**PD Modification Application:** PRS 24-1124  
**Zoning Hearing Master Date:** NA  
**BOCC Land Use Meeting Date:** December 10, 2024

PD 18-0943, as most recently modified by PRS 23-0744 was approved in 2023 to allow for 61 attached (townhomes) conventional residential units. The applicant requests to modify the PD to reduce the dwelling units to 33, and to relocate the access to W. Broad St.

### 2.4 Approved Site Plan (partial provided below for size and orientation purposes. See Section 8.1 for full site plan)

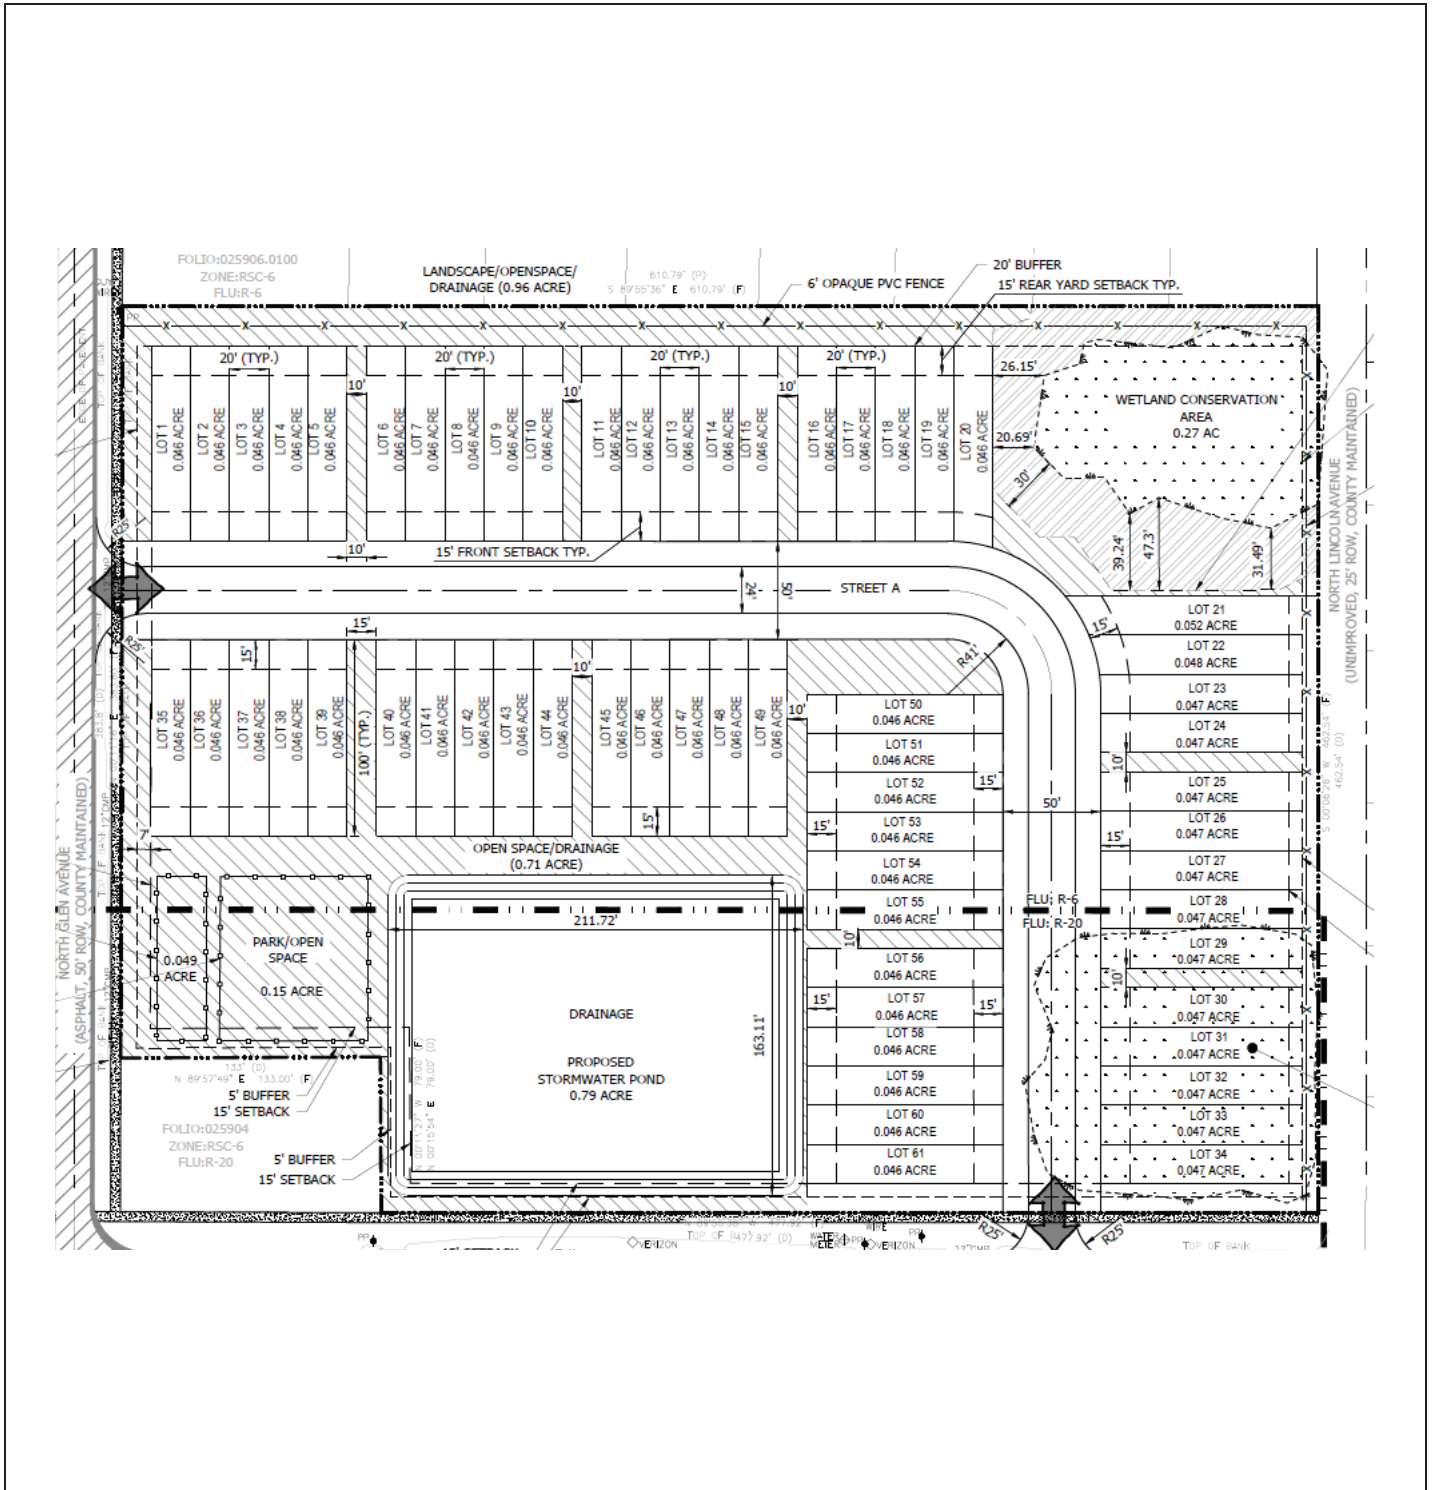
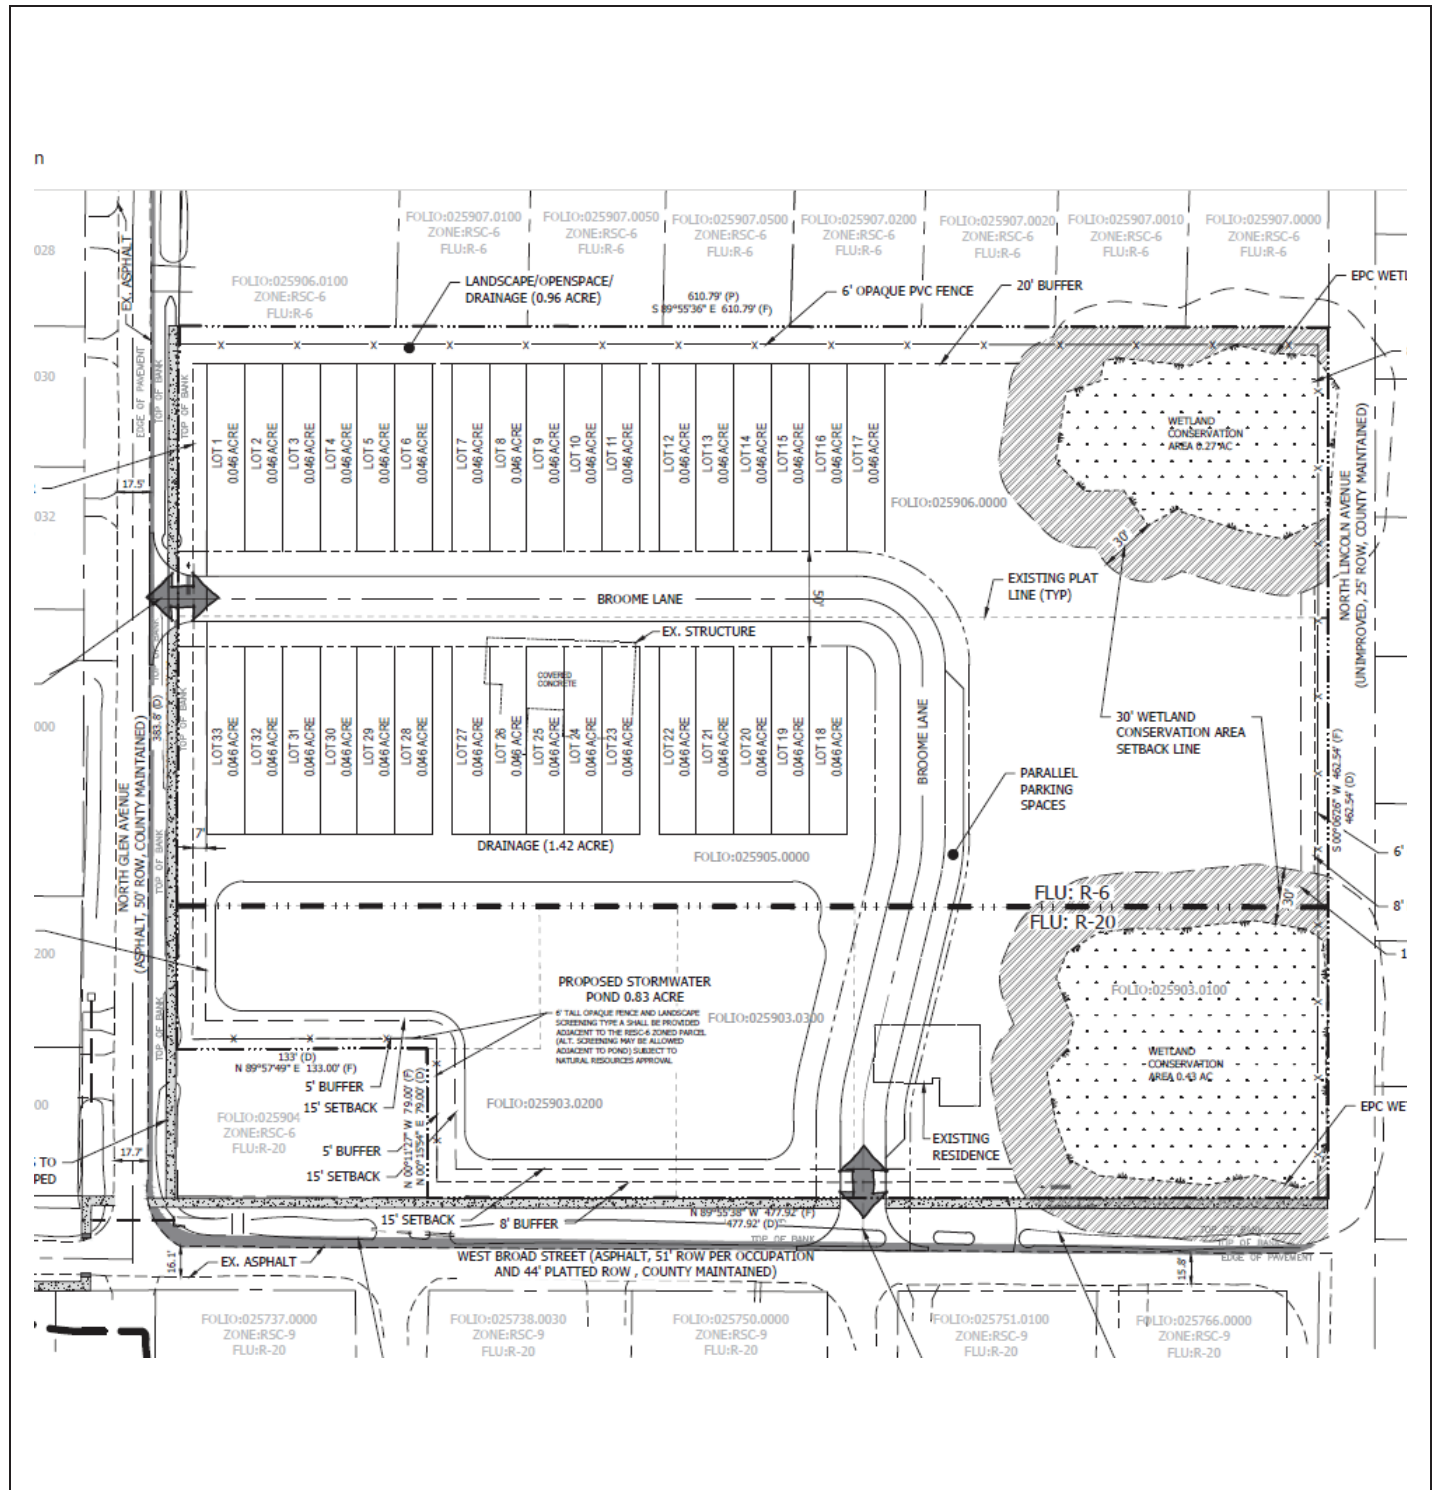
Existing Approval(s):	Proposed Modification(s):
The project shall be developed with up to 61 attached, (townhomes) residential units.	The project shall be developed with up to 33 attached, (townhomes) residential units.
Access to Broad Street as shown on the site plan PRS 23-0744.	To shift the access to W. Broad St. west +/- 40 Ft.

1. The project shall be developed with up to ~~61~~ 33 attached, (townhomes) residential units.

4. The project shall construct one (1) vehicular and pedestrian access to N. Glen Ave. and one (1) vehicular and pedestrian access to W. Broad St.

Figure 2 – Crowned Modification Option to Hillsborough County TTM TS-7

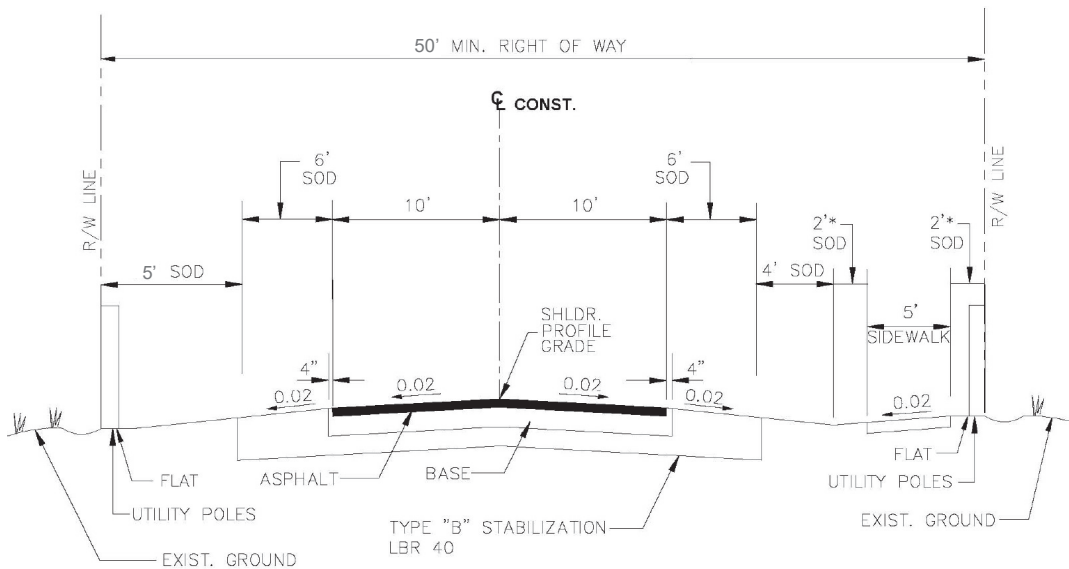
1. According to the Hillsborough County Right of Way Inventory W Broad St has approximately 44 feet of ROW. Surveyed information indicates the ROW for W Broad St varies with a minimum width of 50 feet. TS-7 requires 84 feet with 10-foot travel lanes, 6-foot shoulders, 5-foot sidewalk and open drainage. There are existing 9-foot travel lanes and no sidewalks.
2. This ROW constraint is the main reason for the modification to TS-7. Due to the private property on the west end of this W Broad St segment (at N Glen Ave), the proposed section must be within the existing right of way.

The County Engineer has reviewed zoning modification application # 24-1124 and determined the changes to be de minimis. As such, the previous approval shall stand.

Figure 3 – Currently Proposed Modification to Hillsborough County TTM TS-7

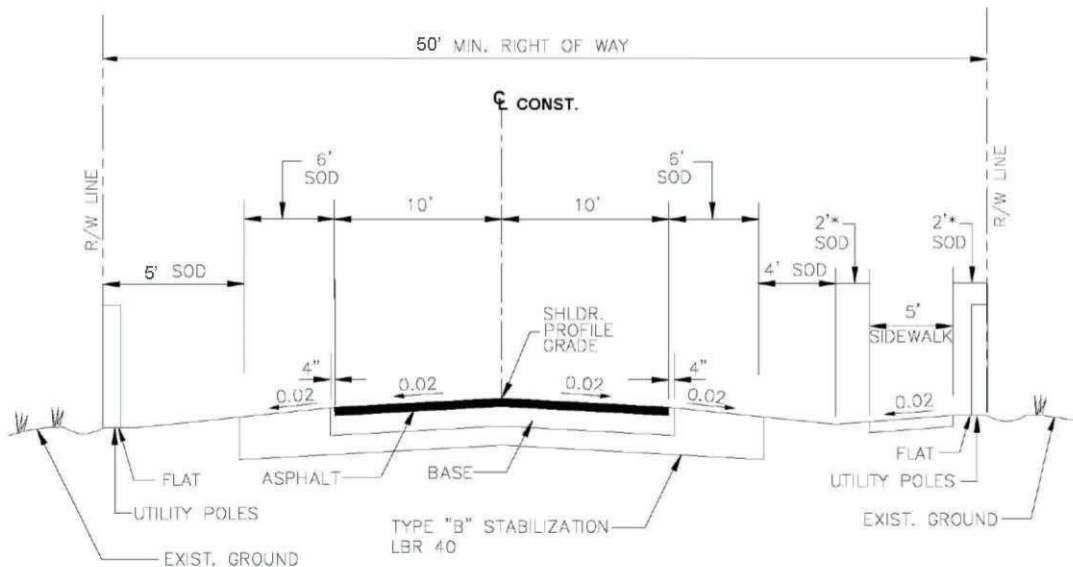
1. Based upon recently obtained survey along this segment, there is 50 feet of right of way available on N. Glen Avenue. TS-7 requires 96 feet with 12-foot travel lanes, 8-foot shoulders, 5-foot sidewalk and open drainage. There are existing 9-foot travel lanes, no paved shoulders, open drainage and no sidewalks.
2. The request is to provide 10-foot travel lanes from W. Kirby Street south along N Glen Avenue to W Broad Street. Based on section 3.1.1 of the Transportation Technical Manual, 10 feet is the minimum lane width for local residential roads. Furthermore, the FDOT Florida Greenbook, Section 3-62, Table 3 identifies the minimum lane width for

local urban roads as 10 feet, however, notes that 9-foot lane widths may be used in residential areas where right of way is limited.

3. The request is to provide 6-foot stabilized shoulders in lieu of the 8-foot shoulders.
4. Reduce the width of the open drainage, as shown in Figure 2. The open drainage on the east side of N. Glen Avenue is proposed to remain unchanged.
5. A 5-foot sidewalk will be provided on the east side of N Glen Avenue from W Kirby Street to W Broad Street.

- The developer shall be able to utilize a 50-foot-wide right-of-way in lieu of the 96-foot-wide right-of-way required per TTM TS-7.
- The developer shall be permitted to provide 10-foot-wide travel lanes in lieu of the 12-foot-wide lanes required per TS-7.
- The developer shall be permitted to provide 6-foot-wide-stabilized but unpaved shoulders in lieu of the 8-foot-wide stabilized shoulders, of which 5-feet are required to be paved per TS-7; and,
- The developer shall be permitted to provide a 5-foot-wide sidewalk along the east side of the roadway with a 12-foot minimum spacing between the closest edge of the travel lane and closest edge of the sidewalk, in lieu of the 29-foot spacing required per TS-7.

Figure 2 – Crowned Modification Option to Hillsborough County TTM TS-7

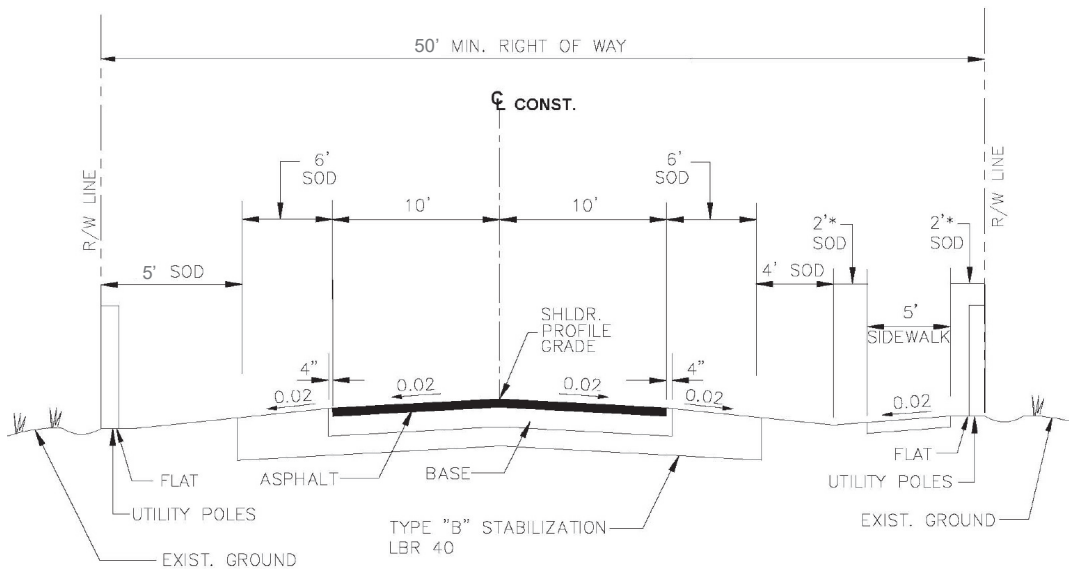
1. According to the Hillsborough County Right of Way Inventory W Broad St has approximately 44 feet of ROW. Surveyed information indicates the ROW for W Broad St varies with a minimum width of 50 feet. TS-7 requires 84 feet with 10-foot travel lanes, 6-foot shoulders, 5-foot sidewalk and open drainage. There are existing 9-foot travel lanes and no sidewalks.
2. This ROW constraint is the main reason for the modification to TS-7. Due to the private property on the west end of this W Broad St segment (at N Glen Ave), the proposed section must be within the existing right of way.

The County Engineer has reviewed zoning modification application # 24-1124 and determined the changes to be de minimis. As such, the previous approval shall stand.

Figure 3 – Currently Proposed Modification to Hillsborough County TTM TS-7

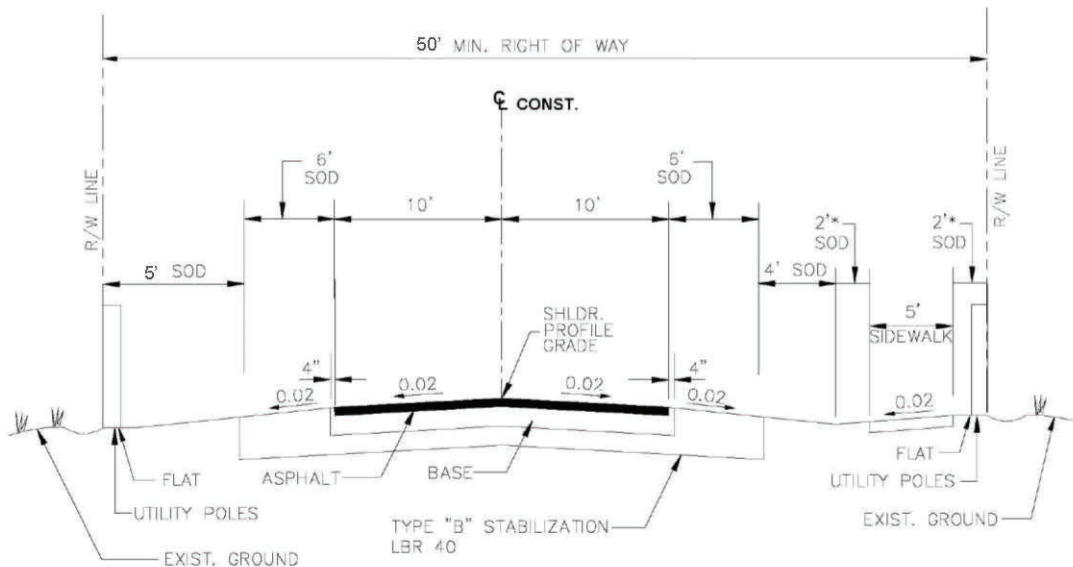
1. Based upon recently obtained survey along this segment, there is 50 feet of right of way available on N. Glen Avenue. TS-7 requires 96 feet with 12-foot travel lanes, 8-foot shoulders, 5-foot sidewalk and open drainage. There are existing 9-foot travel lanes, no paved shoulders, open drainage and no sidewalks.
2. The request is to provide 10-foot travel lanes from W. Kirby Street south along N Glen Avenue to W Broad Street. Based on section 3.1.1 of the Transportation Technical Manual, 10 feet is the minimum lane width for local residential roads. Furthermore, the FDOT Florida Greenbook, Section 3-62, Table 3 identifies the minimum lane width for

local urban roads as 10 feet, however, notes that 9-foot lane widths may be used in residential areas where right of way is limited.

3. The request is to provide 6-foot stabilized shoulders in lieu of the 8-foot shoulders.
4. Reduce the width of the open drainage, as shown in Figure 2. The open drainage on the east side of N. Glen Avenue is proposed to remain unchanged.
5. A 5-foot sidewalk will be provided on the east side of N Glen Avenue from W Kirby Street to W Broad Street.

- The developer shall be able to utilize a 50-foot-wide right-of-way in lieu of the 96-foot-wide right-of-way required per TTM TS-7.
- The developer shall be permitted to provide 10-foot-wide travel lanes in lieu of the 12-foot-wide lanes required per TS-7.
- The developer shall be permitted to provide 6-foot-wide-stabilized but unpaved shoulders in lieu of the 8-foot-wide stabilized shoulders, of which 5-feet are required to be paved per TS-7; and,
- The developer shall be permitted to provide a 5-foot-wide sidewalk along the east side of the roadway with a 12-foot minimum spacing between the closest edge of the travel lane and closest edge of the sidewalk, in lieu of the 29-foot spacing required per TS-7.
